JANUARY 19, 2021 MEETING

McGuinness Residence, 17 Schoolhouse Road, Waccabuc, NY 10597, Sheet 22, Block 10802, Lot 35 (Annette and Peter McGuinness, owners of record) - Application for the construction of a greenhouse, covered dining area, spa and extension of an existing patio.

TO: The Town of Lewisboro Planning Boar
FROM: Lewisboro Conservation Advisory Council
SUBJECT: **McGuiness Residence, 17 Schoolhouse Road**
South Salem, NY 10590
DATE: January 13, 2021

**Re: 17 School House Road
Sheet 22, Block 10802, Lot 35
Application for Wetland Permit and Stormwater Permit**

PROPOSED GREENHOUSE CONCEPT AT SUBJECT AREA 2

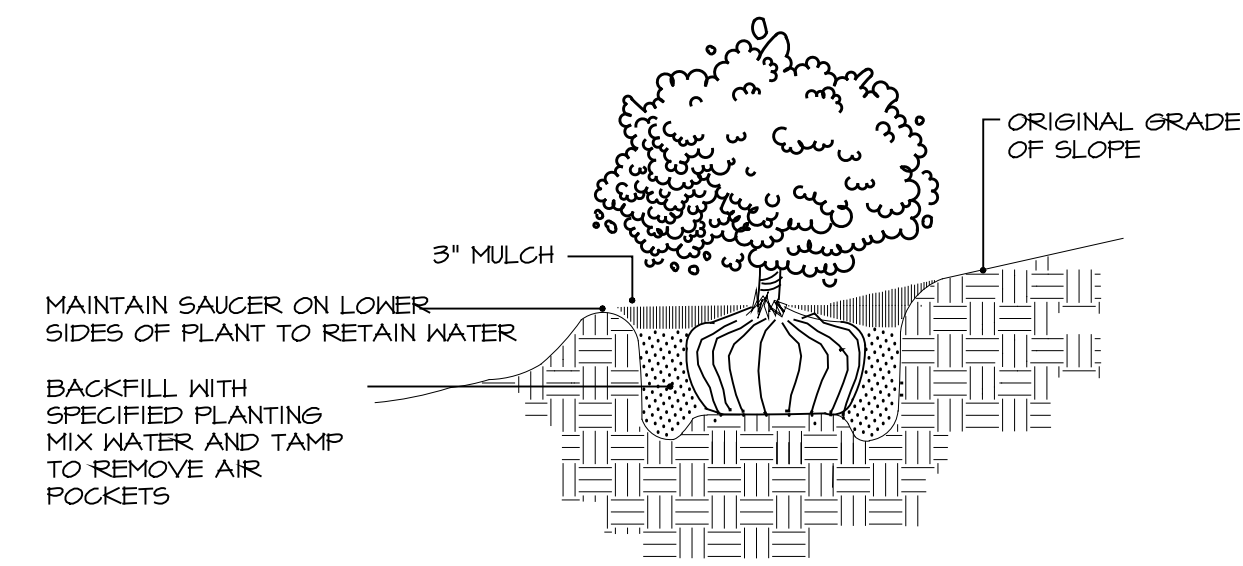
- The CAC notes that the plans call for the greenhouse to be built near but not actually on the footprint of the existing shed that is to be removed in the paddock. Though the CAC realizes that the applicant would prefer the greenhouse to be located near the wildflower garden, can the building in fact be placed outside the buffer nearby, in order to reduce the amount of construction within the buffer?
- The CAC would like to see the list of plantings in the wildflower garden when it is available, in the interest of including and combining plantings with native flora.

Greenhouse - The proposed greenhouse will replace the existing shed in the original lamb paddock on the west side of the driveway. This area is situated in the 150' wetland buffer. The greenhouse will be centrally located in the existing paddock in order to be best positioned to the adjacent flower gardens that are proposed to be installed in this paddock area.

SWPPP Figure 3

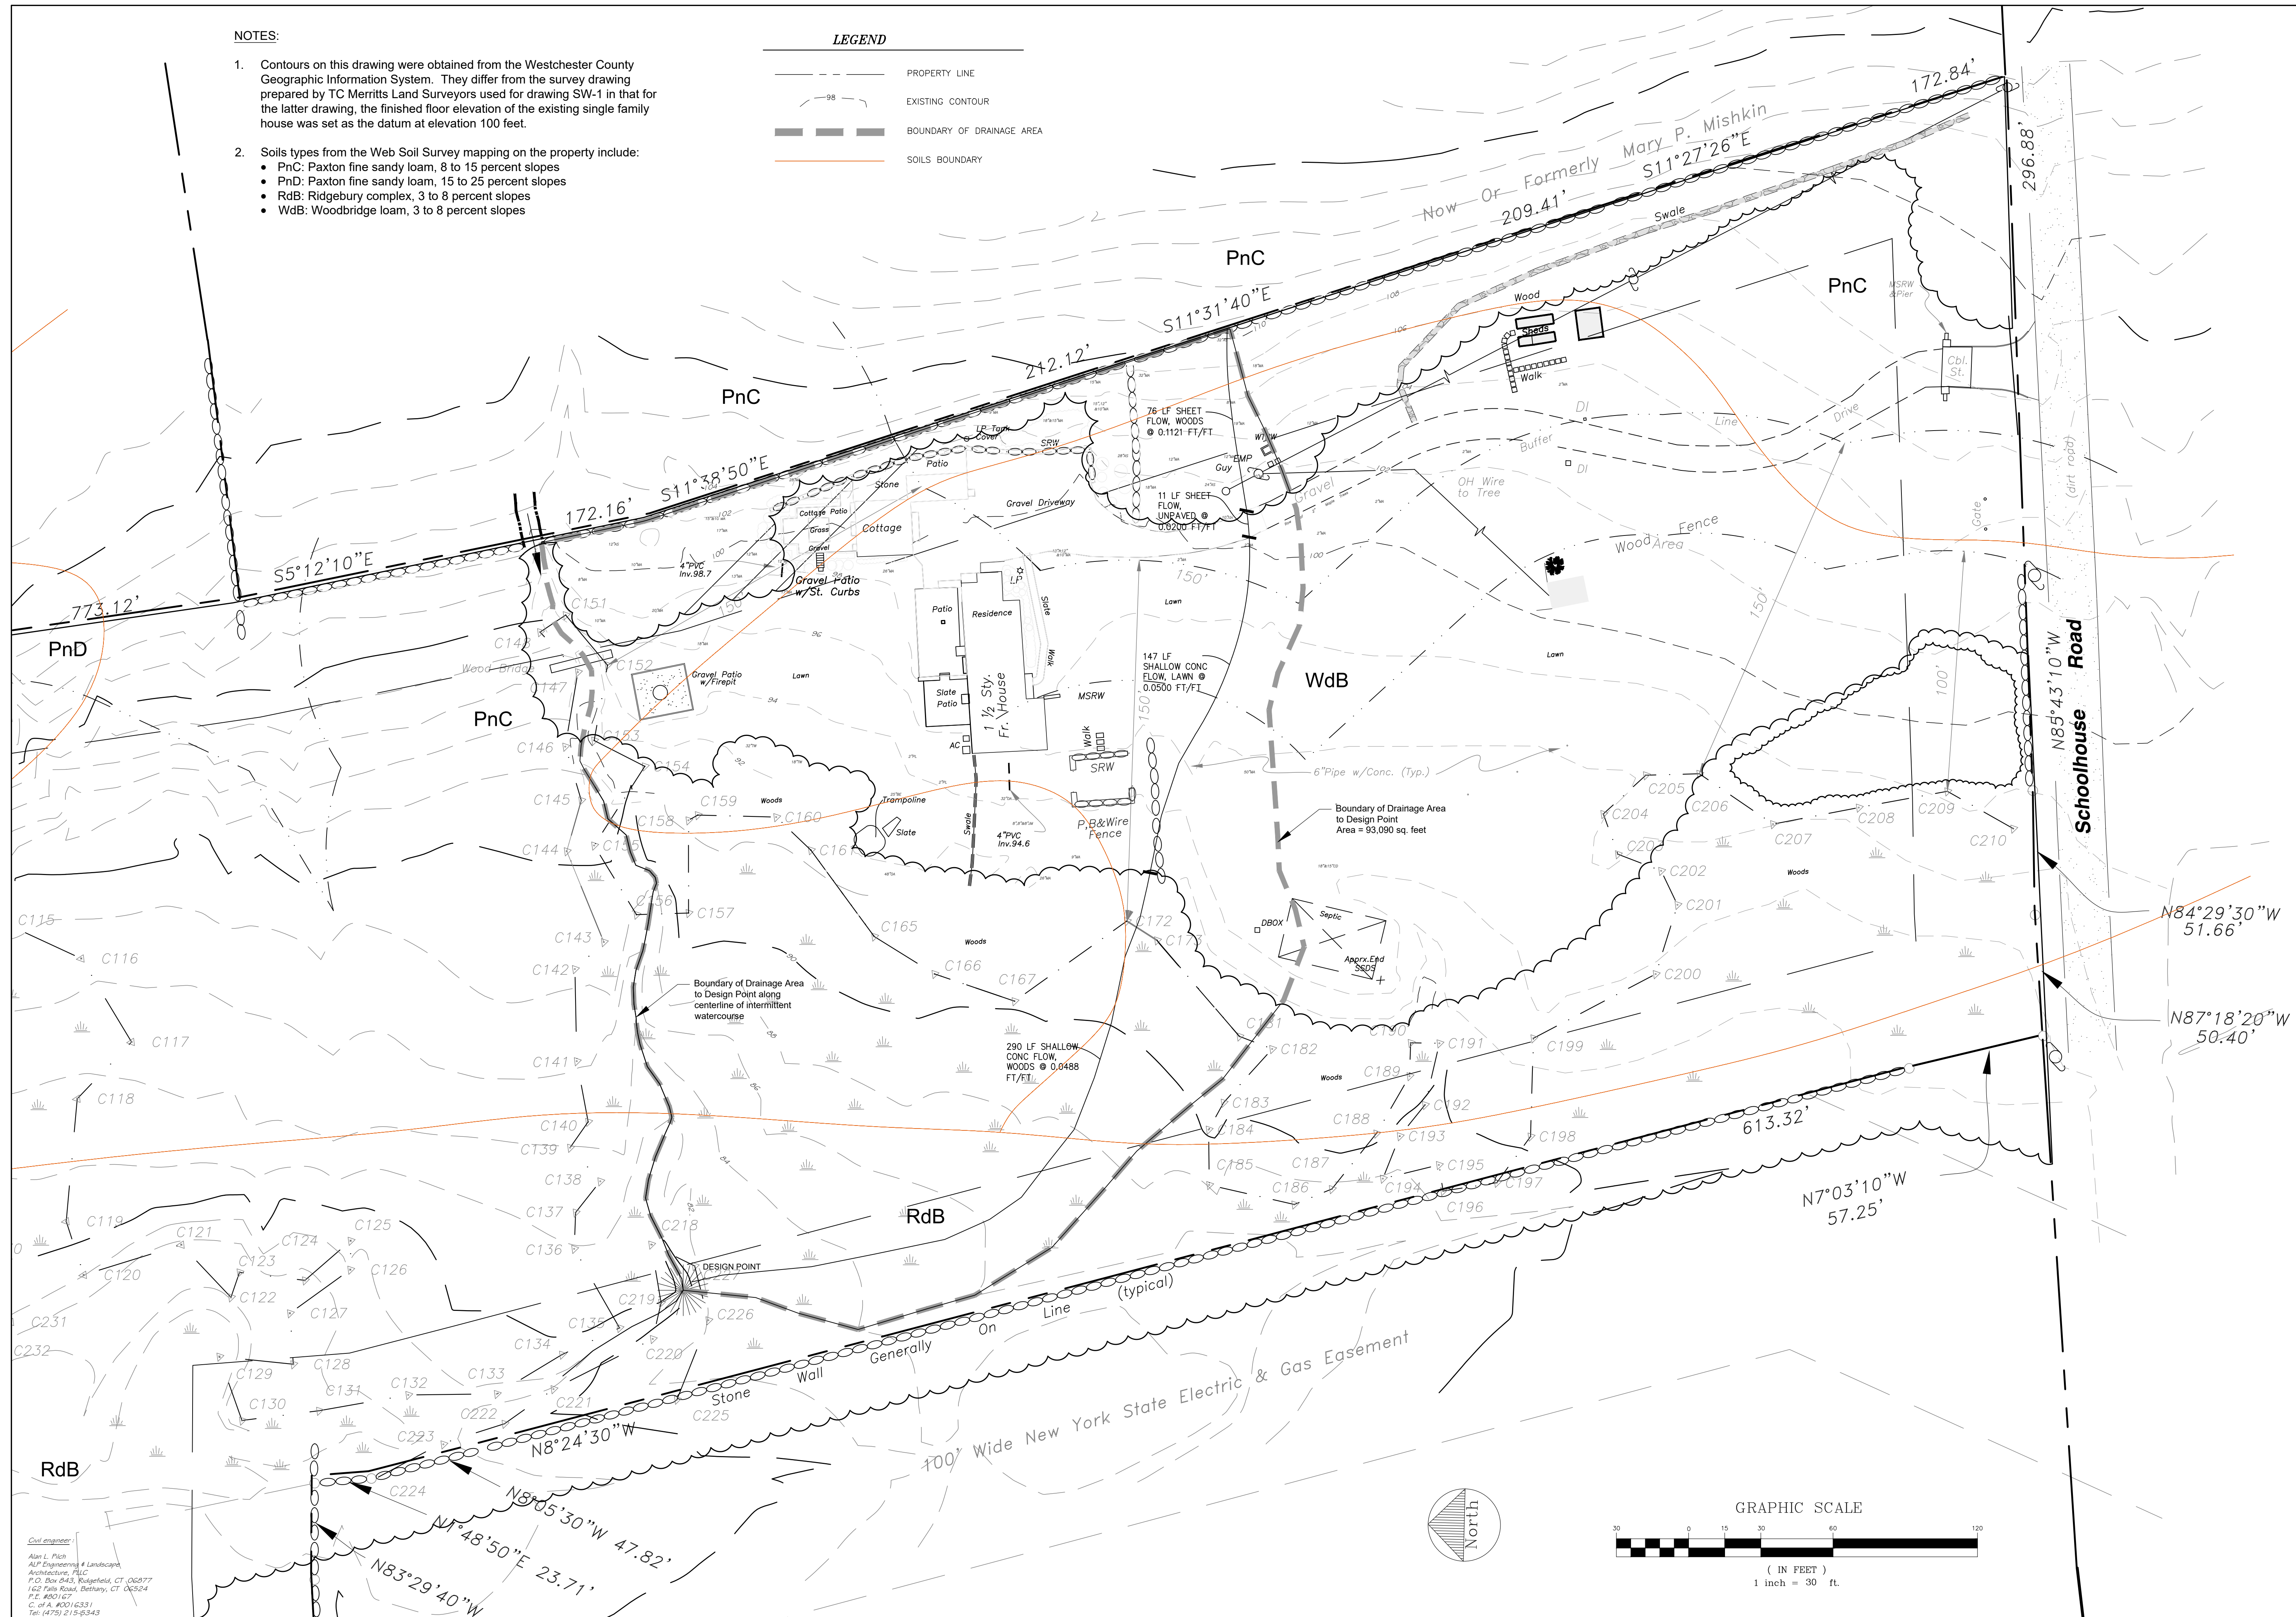
9. The applicant shall perform deep and percolation soil testing in the vicinity of the proposed mitigation system to be witnessed by the Town Engineer. The test locations and results shall be shown on the plan. Contact this office to schedule the testing.

Response: A deep hole test was performed on December 15, 2020 within the footprint of the proposed stormwater mitigation system. The location of the deep hole test is on sheet SW-1. The details of the deep hole test's findings may be found in the attached SWPPP report and on drawing SW-1. The deep hole test was witnessed by Kellard Sessions Consulting.
